Invitation to Bid #0224-25-05 – Addendum #2
Issue Date: February 24, 2025

Des Plaines Campus – Installation of Batting Cage and Turf

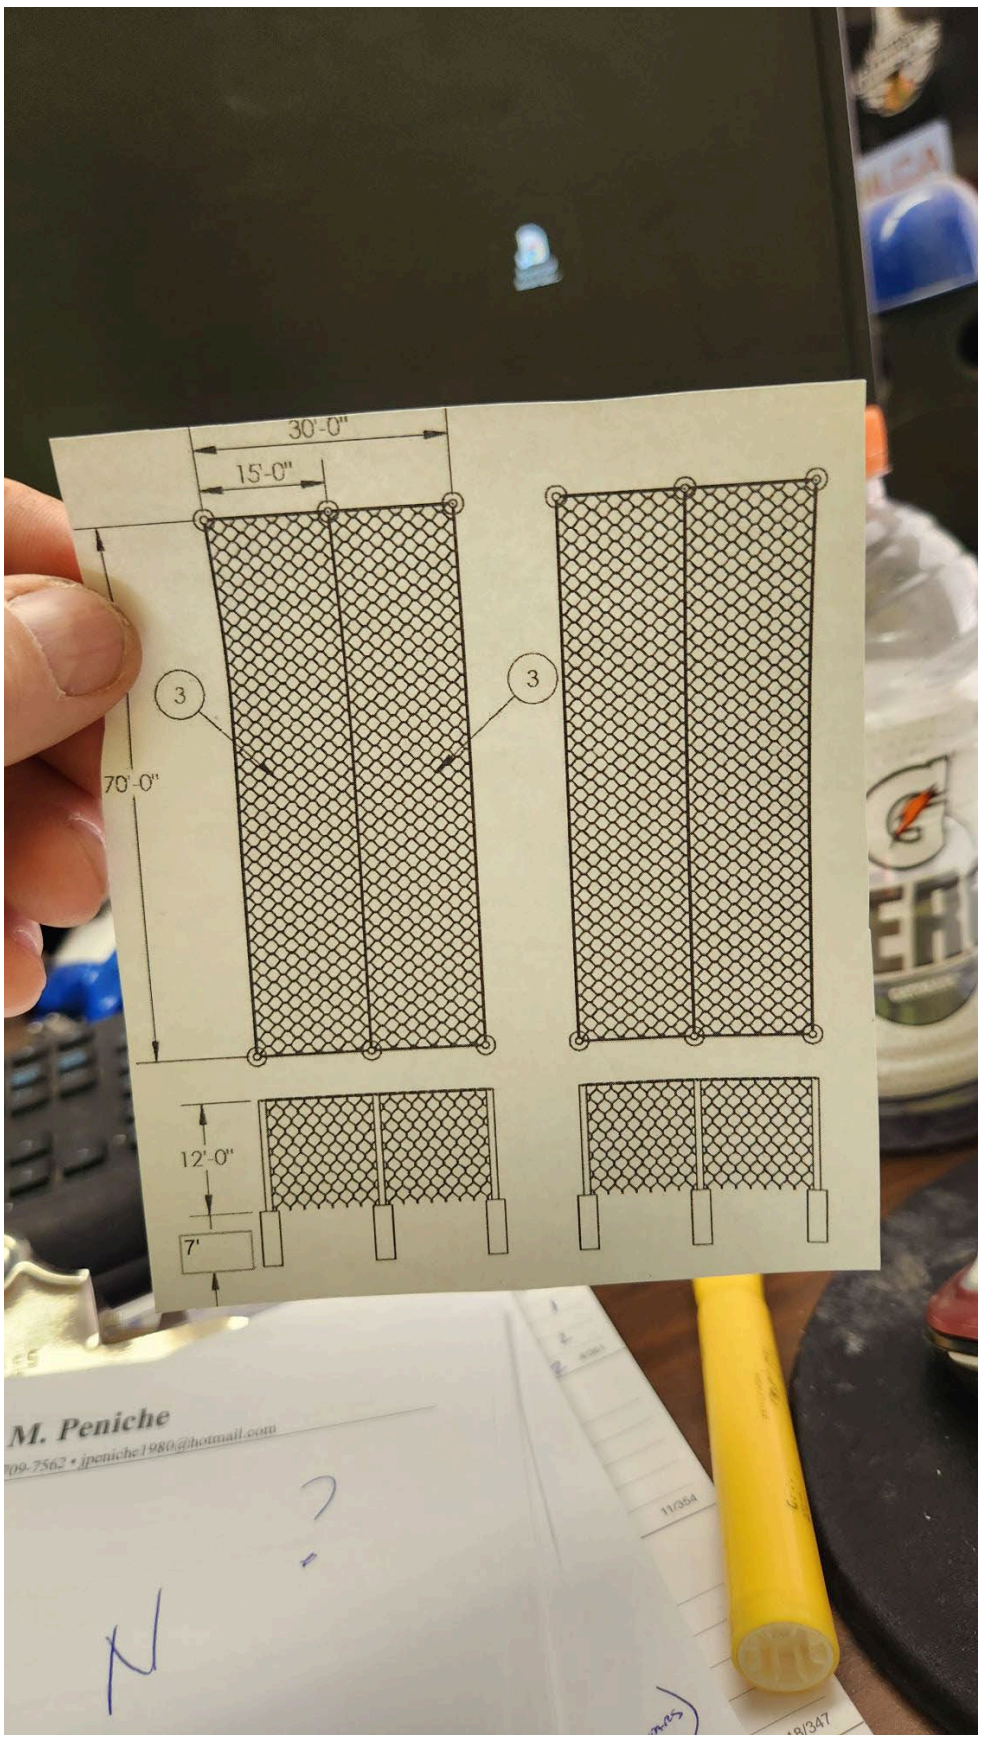
1. I did not see any dimensions for the cage height, and was wondering if you guys would be open to other options of turf.
Answer: 12' tall. Yes, we are open to other turf, however, a turf sample needs to be provided before the installation for approval.
2. A 6 pole system as addressed in addendum #1, question #3 can be interpreted as 6 total poles as shown on the attached note as configuration #1. It was my understanding from the pre-bid meeting that the configuration that is wanted is configuration #2, 6 poles per batting tunnel with a common center pole, 10 total poles.
Answer: We are requiring a 6 pole system per tunnel. See picture below.
